UNITED STATES
NUCLEAR REGULATORY COMMISSION
WASHINGTON, D. C. 20555

The Commission has issued the enclosed Amendments No. 12 to Facility Operating Licenses Nos. DPR-32 and DPR-37 for the Surry Power Station, Units 1 and 2. The amendments include Change No. 27 to the Technical Specifications for each license and are in response to your request dated October 22, 1975.

The amendments revise the provisions in the Technical Specifications relating to the heatup and cooldown limitations of the reactor coolant system.

ATTACHMENT TO LICENSE AMENDMENT NO. 12
CHANGE NO. 27 TO THE TECHNICAL SPECIFICATIONS
FACILITY OPERATING LICENSE NO. DPR-32
DOCKET NO. 50-280

TS FIGURE 3.1-1
NOV 21 1975

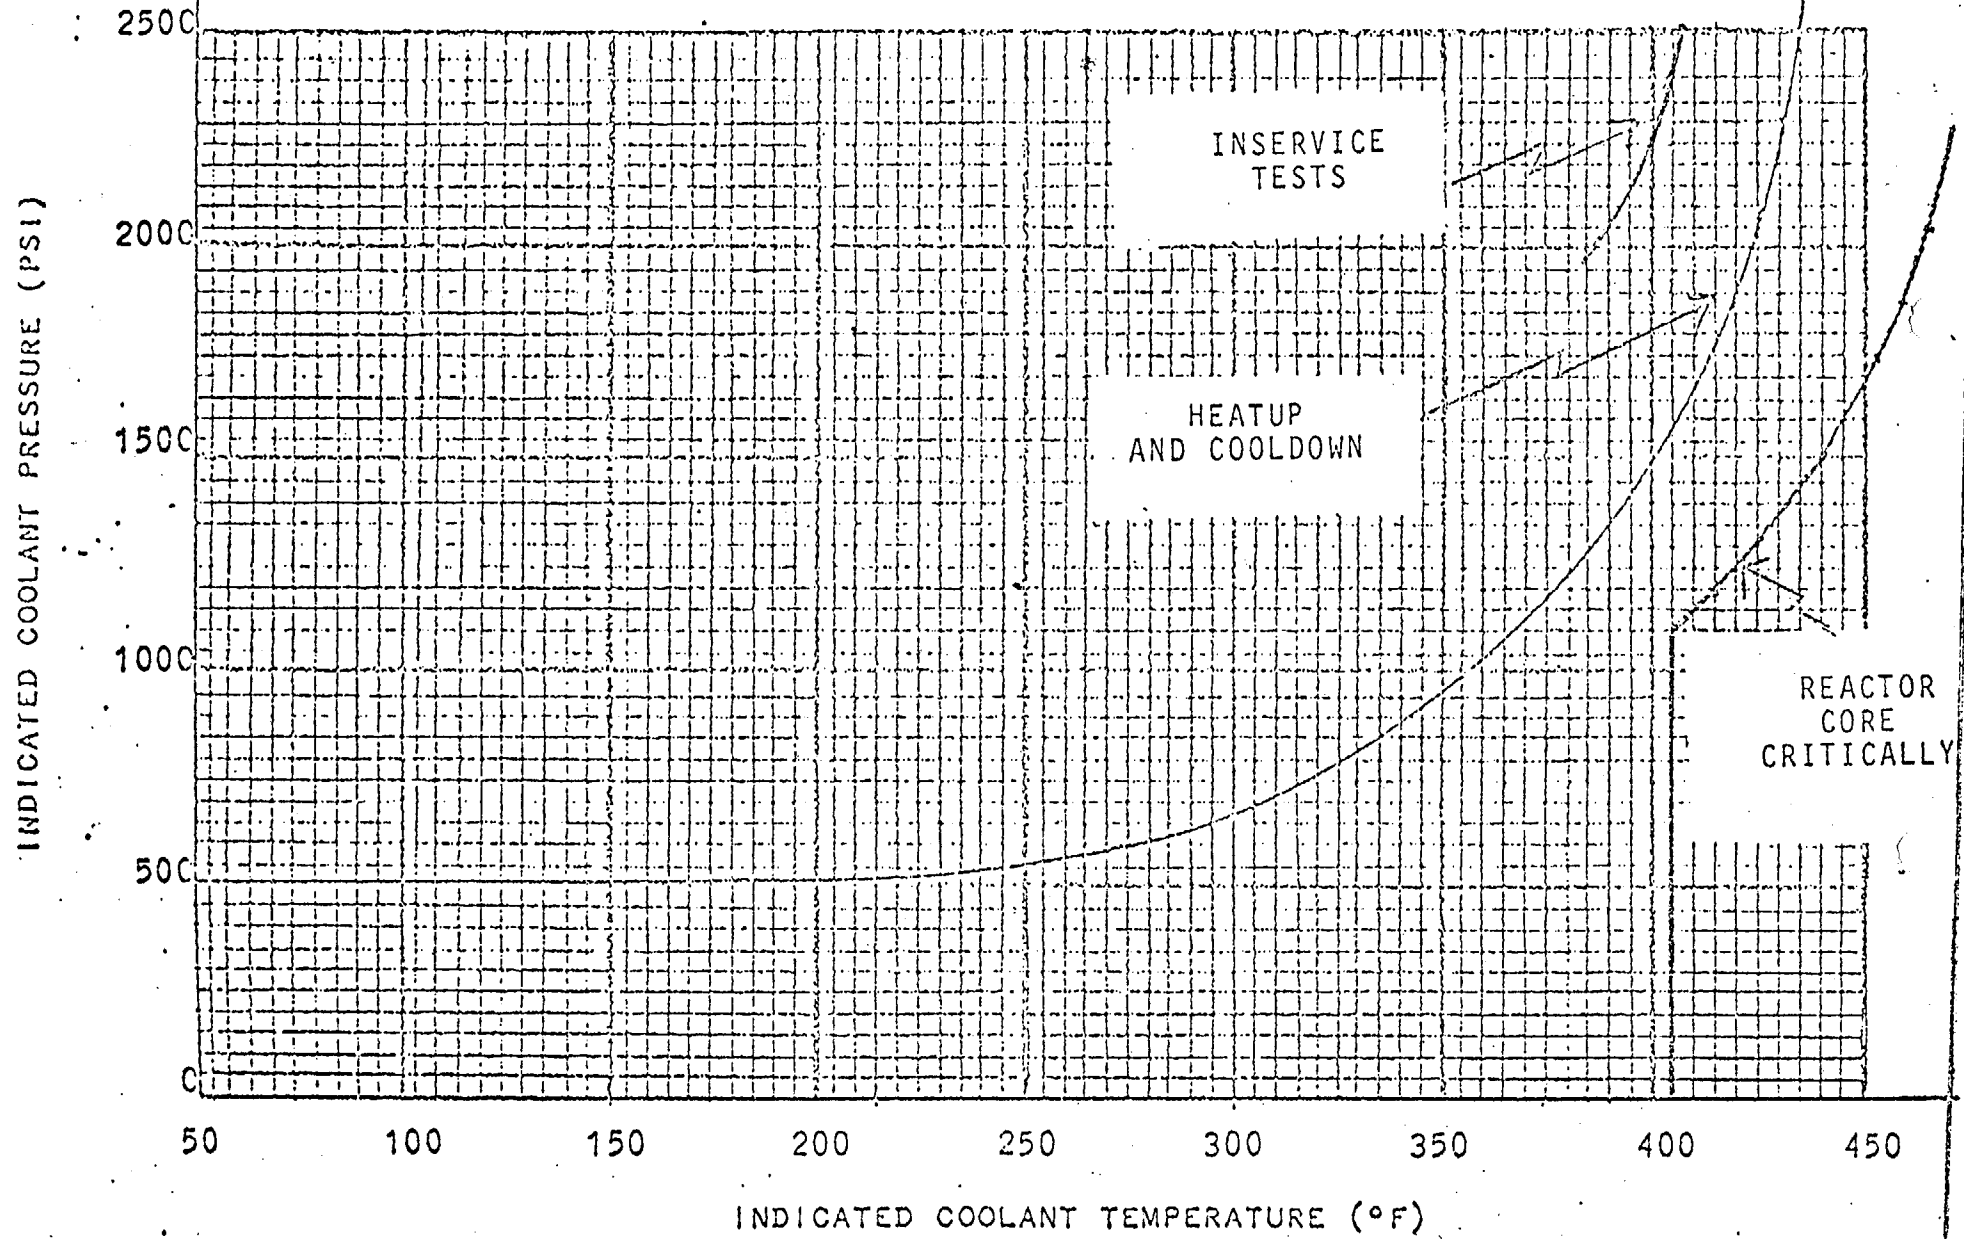
We have evaluated the pressure-temperature limit curve presented in Figure 3.1-1 of the licensee's proposed Technical Specification Change of October 22, 1975 and conclude that it is acceptable for heatup and cooldown pressure-temperature limits. We have augmented this curve to indicate pressure-temperature limits for inservice hydro testing and core criticality. The attached curves provide acceptable limits for these conditions.

The following paragraph has been added to Specification 3.1.B.1:

During operation where the reactor core is in a critical condition (except for low level physics tests), vessel metal and fluid temperature shall be maintained above the reactor core criticality limits specified in Figure 3.1-1."

The following statement has been added to Specification 4.3.A:

"The pressure-temperature limits for these tests will be in accordance with Figure 3.1-1."

1. Unit 1 and Unit 2 reactor coolant temperature and pressure and the system heatup and cooldown (with the exception of the pressurizer) shall be limited in accordance with TS Figure 3.1-1.

Figure 3.1-1 may be used for heatup rates of up to 50°F/hr. below an indicated temperature of 440°F and 100°F/hr. above 440°F.

Allowable combinations of pressure and temperature for specific cooldown rates are below and to the right of the limit line as shown in TS Figure 3.1-1. This rate shall not exceed 50°F/hr. for temperatures at or below an indicated temperature of 440°F. For temperatures above an indicated temperature 440°F, the rate shall not exceed 100°F/hr.

During operation where the reactor core is in a critical condition (except for low level physics tests), vessel metal and fluid temperature shall be maintained above the reactor core criticality limits specified in Figure 3.1-1.

The pressure-temperature limits for these tests will be in accordance with Figure 3.1-1.
